APPEAL OF THE DECISION OF
DEVELOPMENT REVIEW COMMITTEE

PROJECT/APPLICATION: 15 Loma Alta Ave

Appeal of DRC approval decision for 15 Loma Alta Avenue

Architecture and Site Application S-19-023

FRONT ELEVATION @ LOMA ALTA AVE.

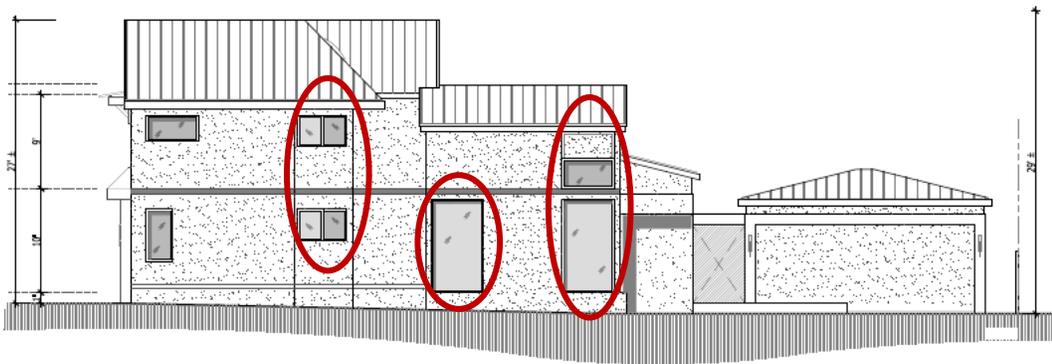
The applicant does not meet this section specifically that the home as designed does not respect the scale of the immediate neighbors. The home which reaches 28’ in height, towers over the 14’ home (**double the height**) to the immediate right. Further, the selection of the Victorian style and massing is not in keeping with the character of the bungalow enclave on this portion of Loma Alta.

3 SIDE ELEVATION

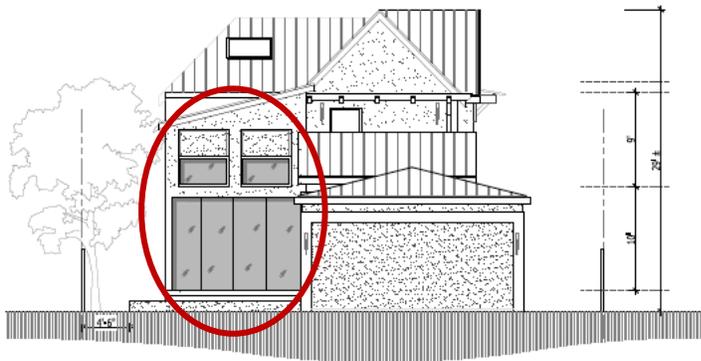
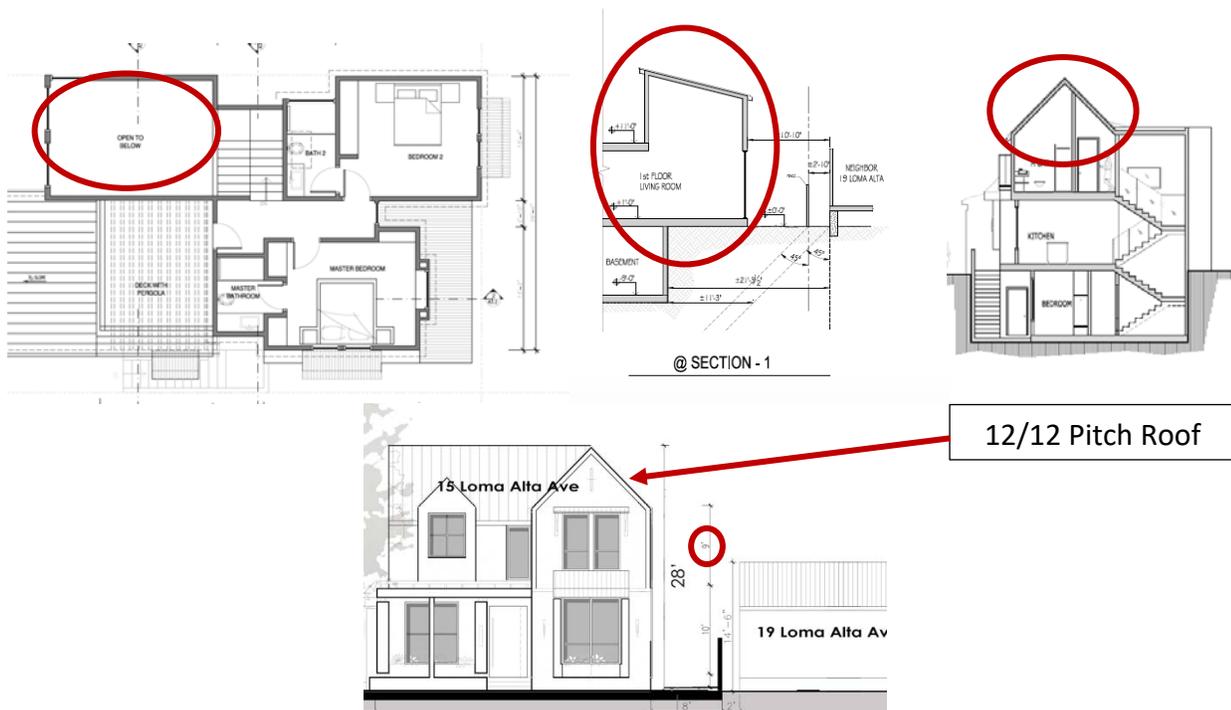
The applicant has transitioned from Victorian forms in the front to Modern flat glass forms in the rear. There is inconsistency in fenestration – placement, types and sizes – throughout the proposal. See the elevations below:

While the proposal is within the FAR requirements, the home as proposed has significantly more mass bulk and scale than the neighboring homes. This is driven by interior elements of vaulted ceilings and open two-story space as well as 9' plate heights in the 2nd floor. Additionally, the use of the Victorian style – 12/12 pitch roof increases the height and mass of the structure.

Large difference in bulk at front setback between the new house and the adjacent neighboring house

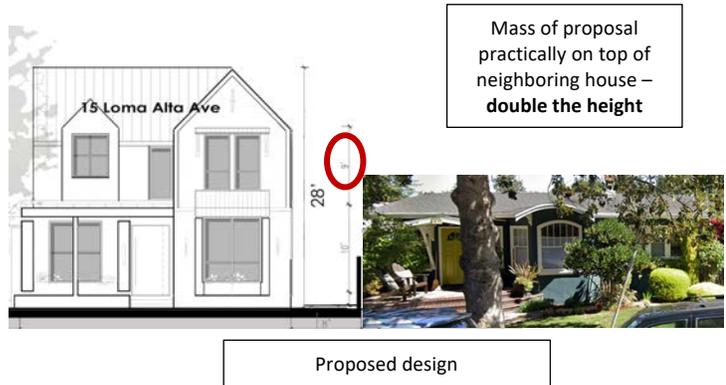
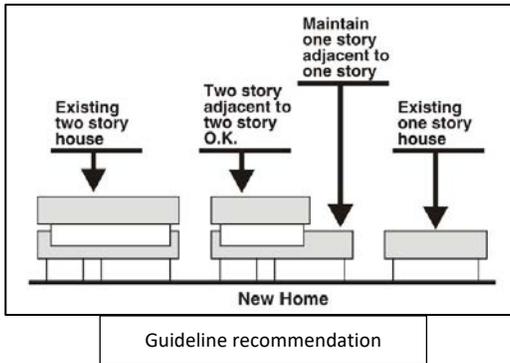
As shown in the illustration below from the applicant’s submission, the home is NOT using the roof mass to minimize the impact of the second story. In fact, with the vertical facades, the height of the structure is emphasized, not minimized thus not blending with the smaller homes in the area.

2.3.2 Avoid structures with height and bulk at front and side setback lines which are significantly greater than those of the adjacent homes

These facades and fenestration have no relation to each other – not a 360 degree design

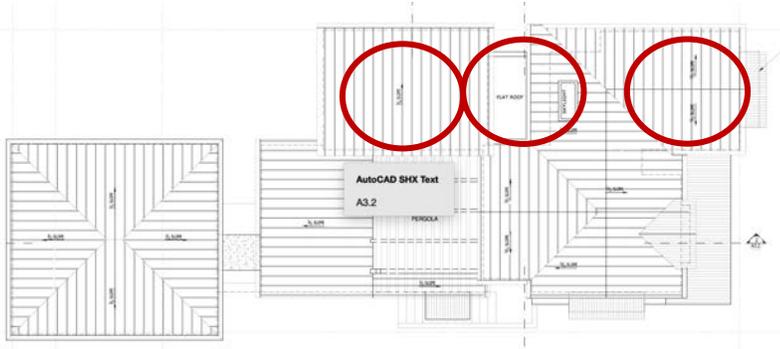
As illustrated in earlier below, it is clear that the rear of this design has no relation to the front. The front tries poorly to be a Victorian design, while the rear tries to be a Modern Contemporary house. There is no 360-degree design that supports architectural integrity.

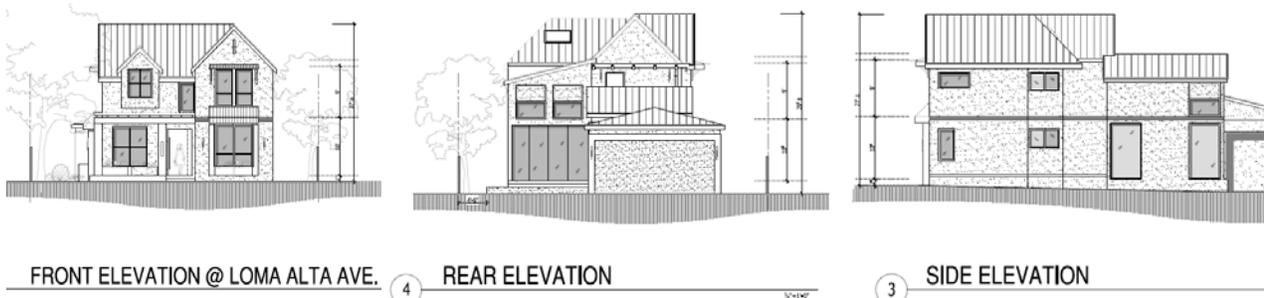
The project as designed has a mishmash of window styles, types and proportions. On the front elevation alone, there are 5 different window sizes and styles. As you take this to the rear and side of the house, there this just grows exponentially. There is no consistency in the design.
